Santa Ana River Wasteload Allocation Model Update

BASIN MONITORING PROGRAM TASK FORCE

November 16, 2017

Response to Comments on TM No. 1

Figure 21

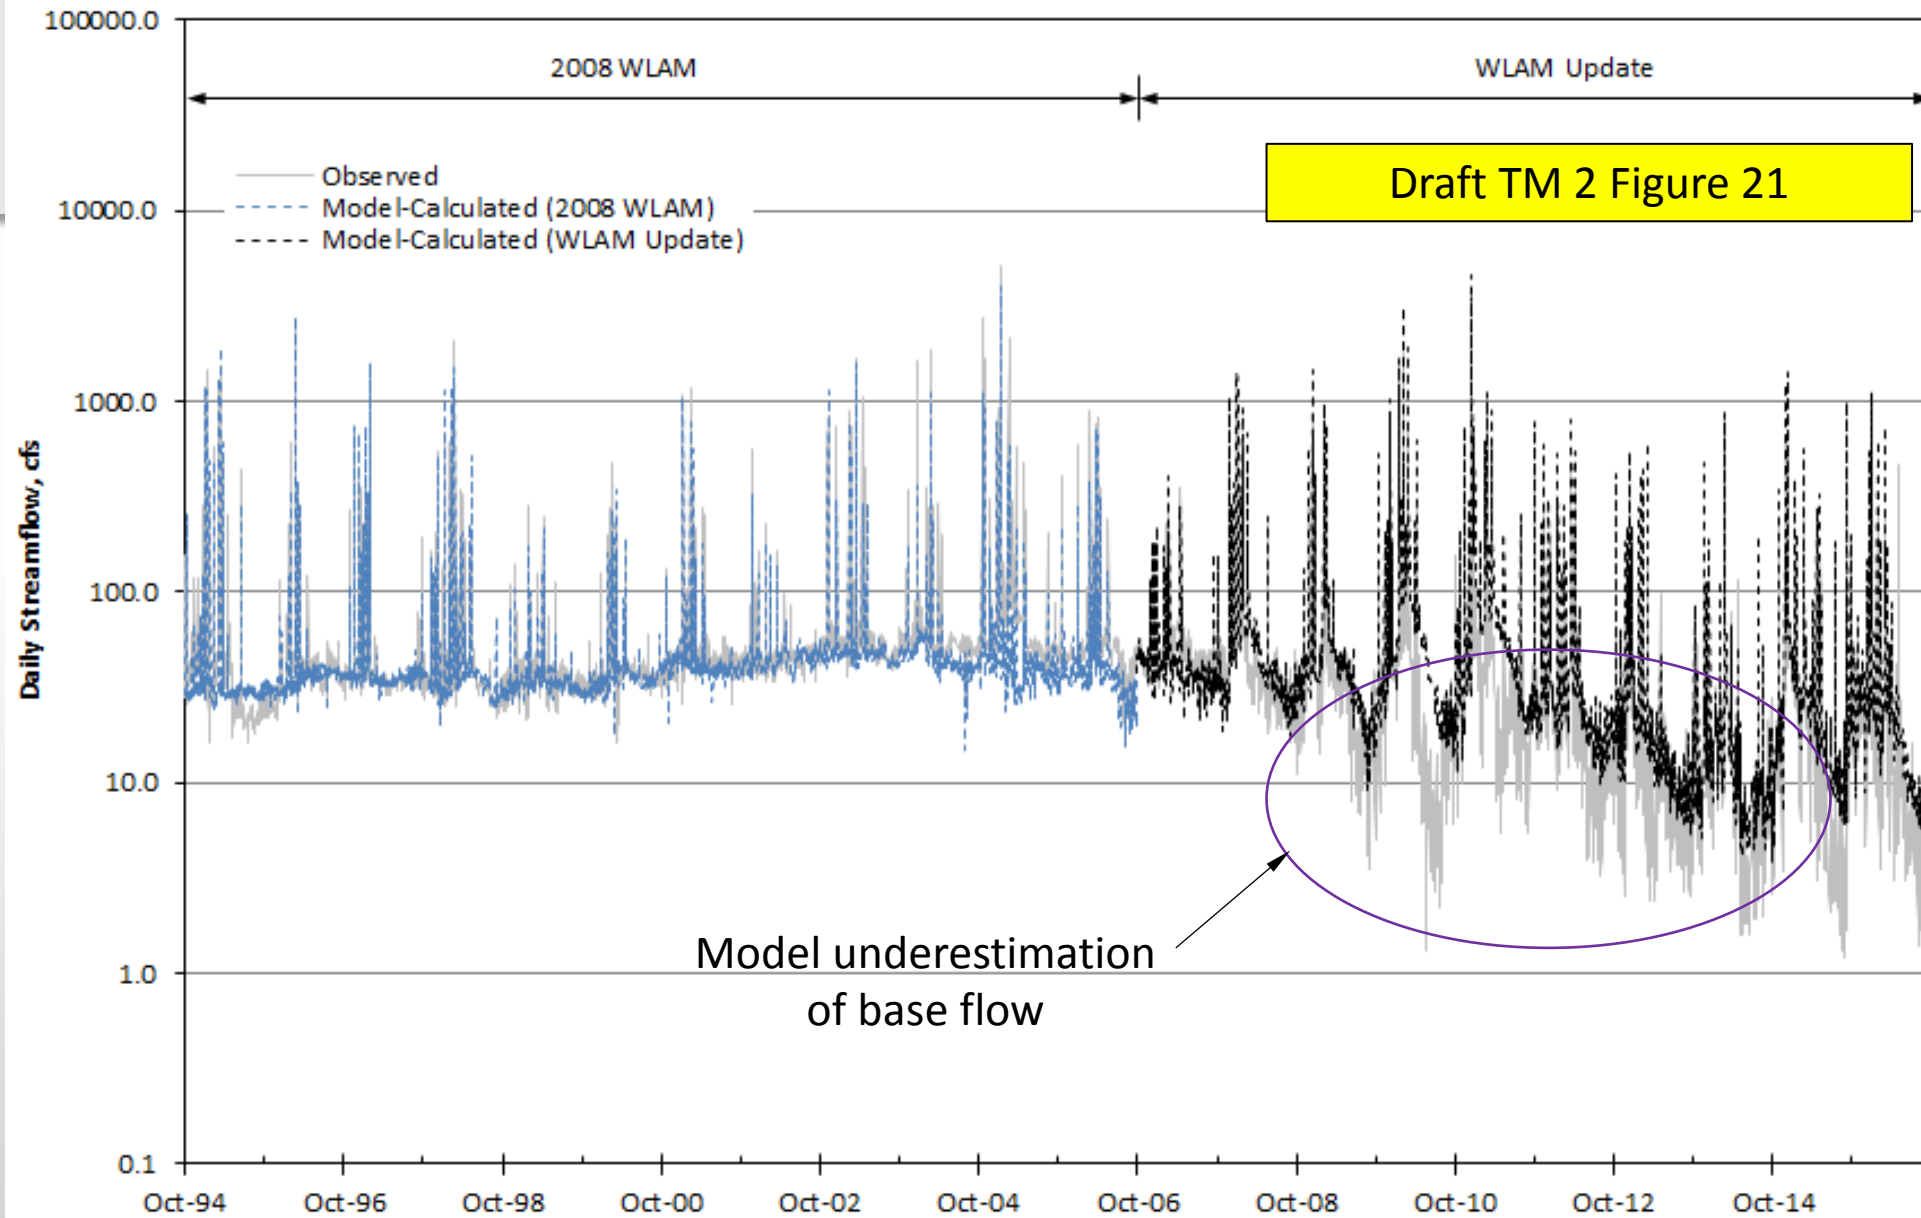
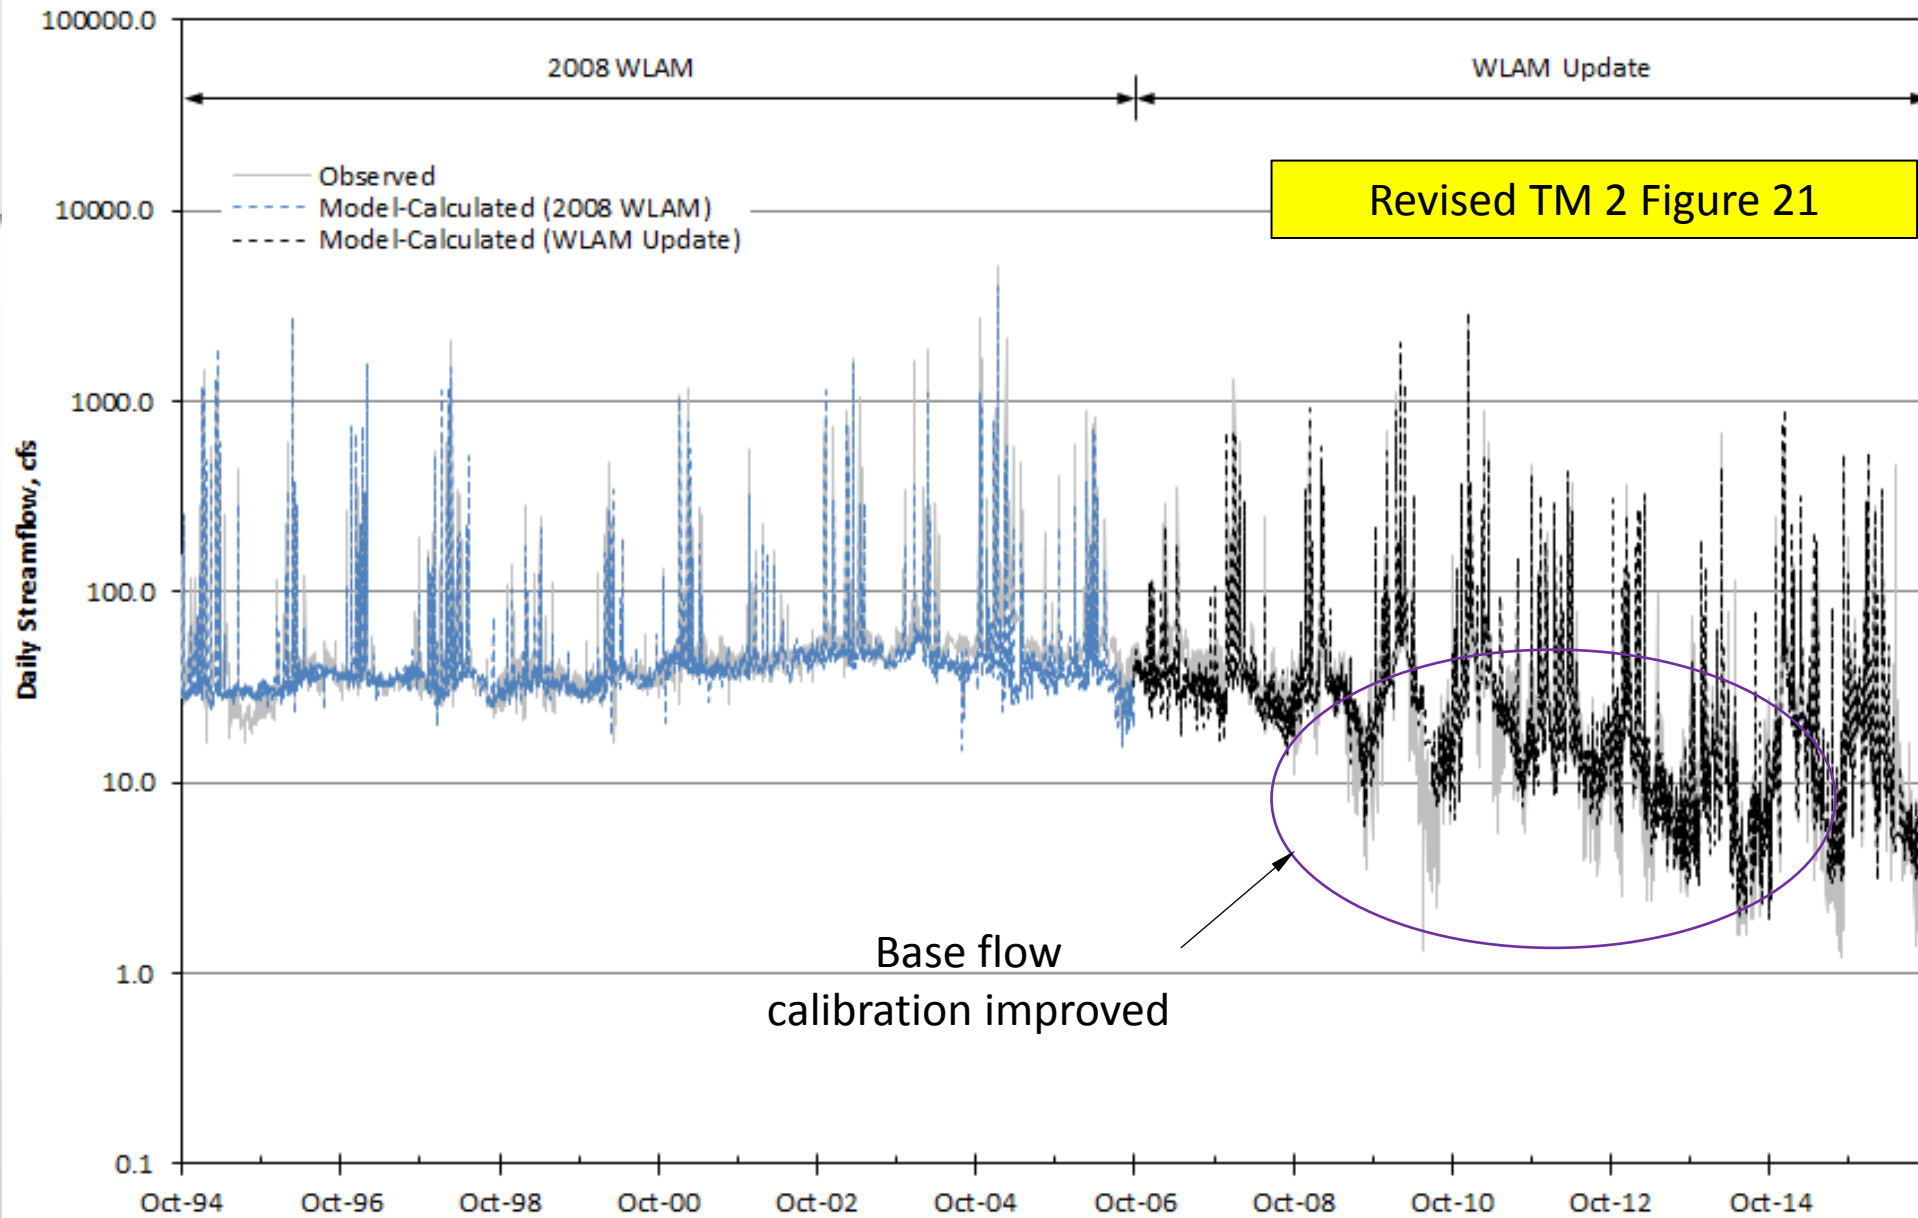
No.	Section	Pg.	Comment	GEOSCIENCE Response
6	General	-	Revisit areas where the model is over/underestimating streamflow and may need improvement (e.g., Figures 20, 21, 24, and 28).	Underperforming areas will be revisited.

Draft TM 2 Figure 48

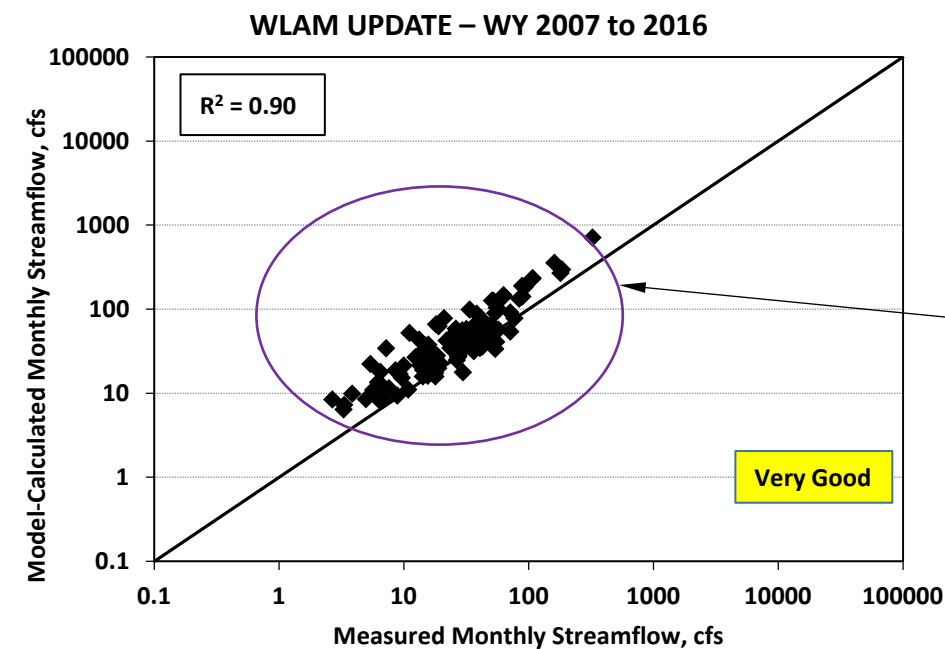
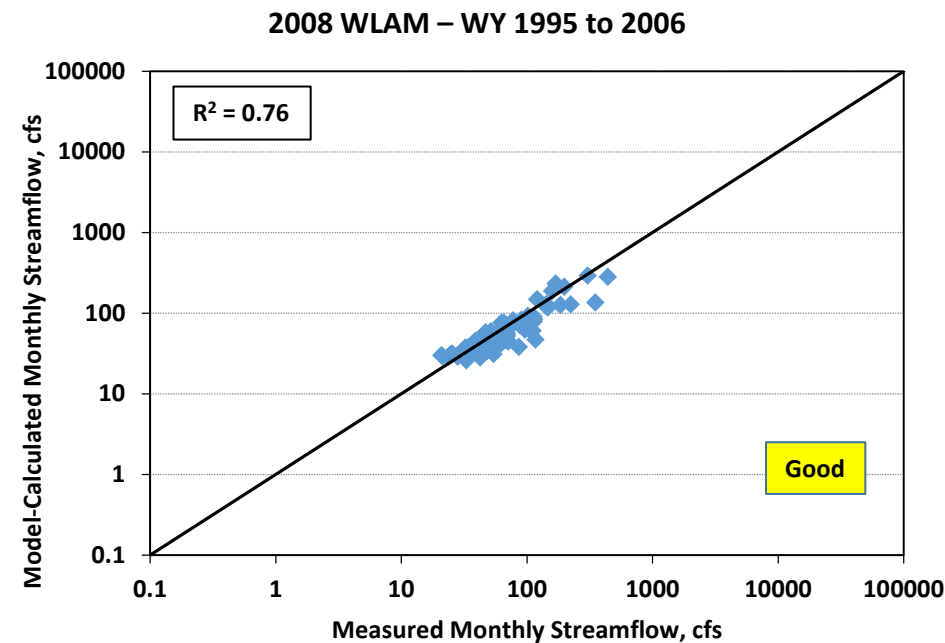
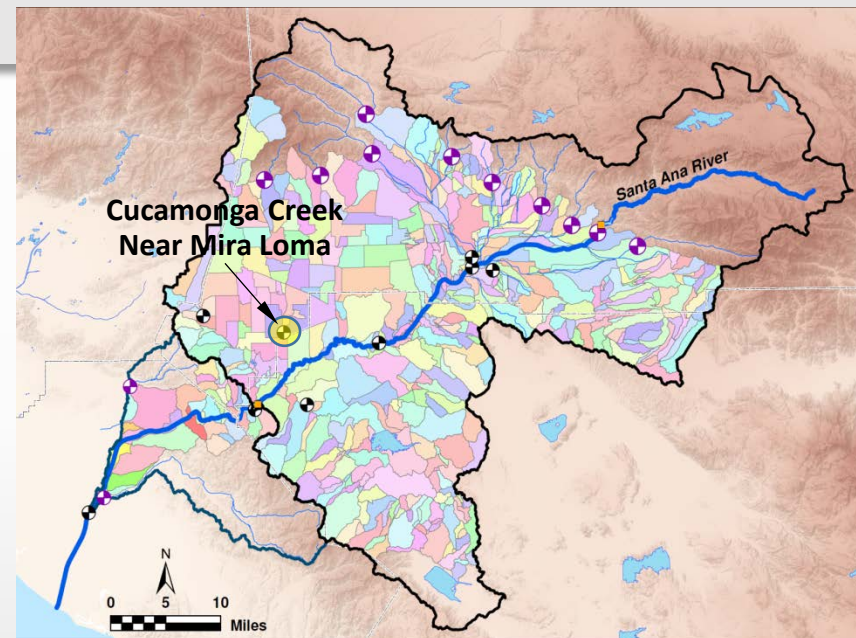
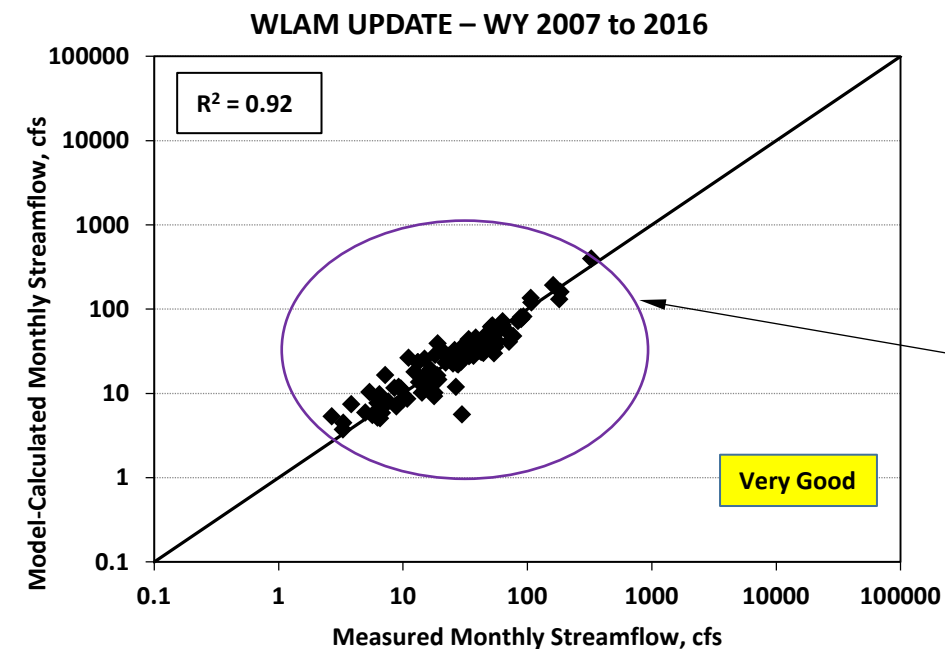
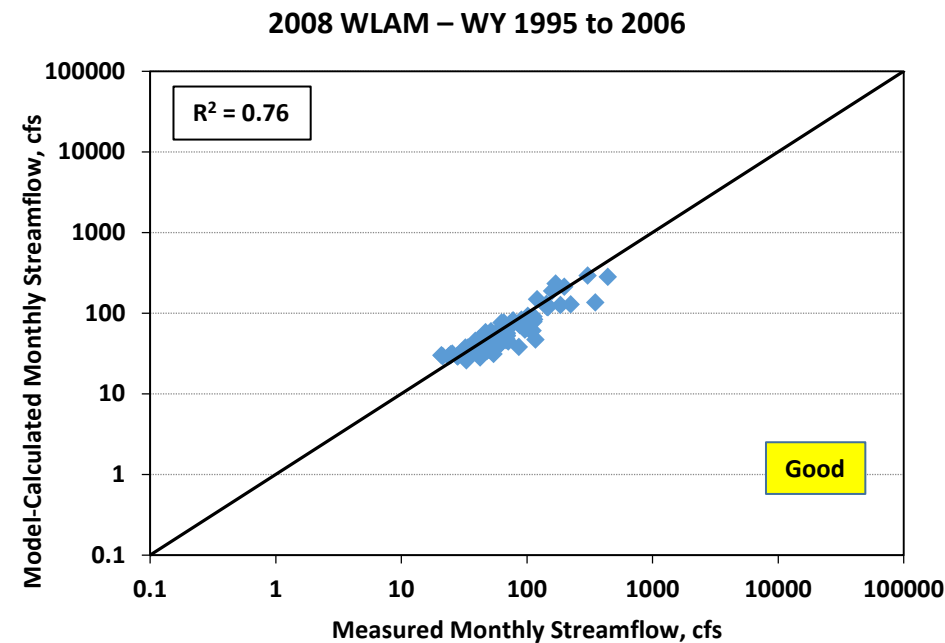
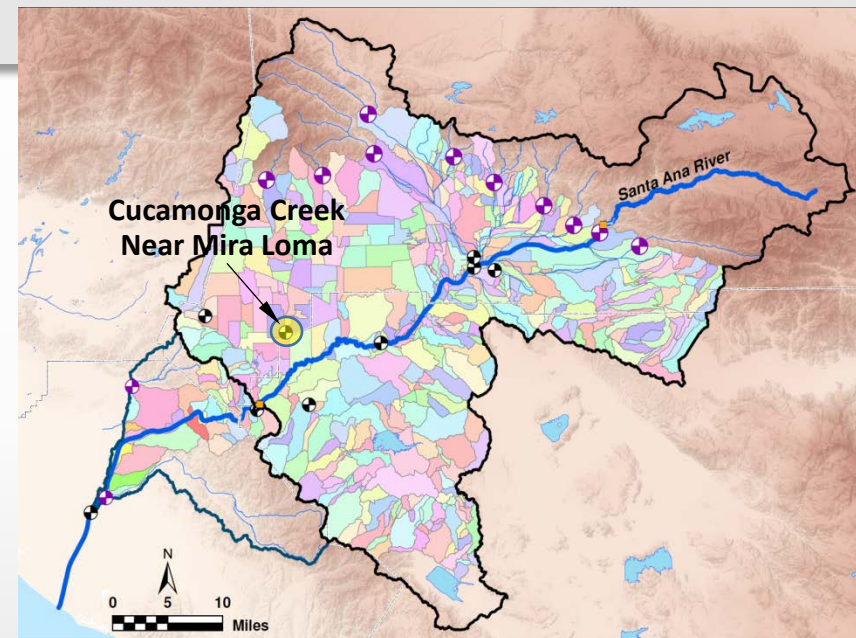
No.	Section	Pg.	Comment	GEOSCIENCE Response
7	Figures	Figure 48	According to the scatter plot shown on Figure 48, the model appears to consistently overestimate streamflow. Please address.	Overestimation was addressed.

Model overestimates streamflow consistently

Revised TM 2 Figure 48

Overestimation of streamflow improved
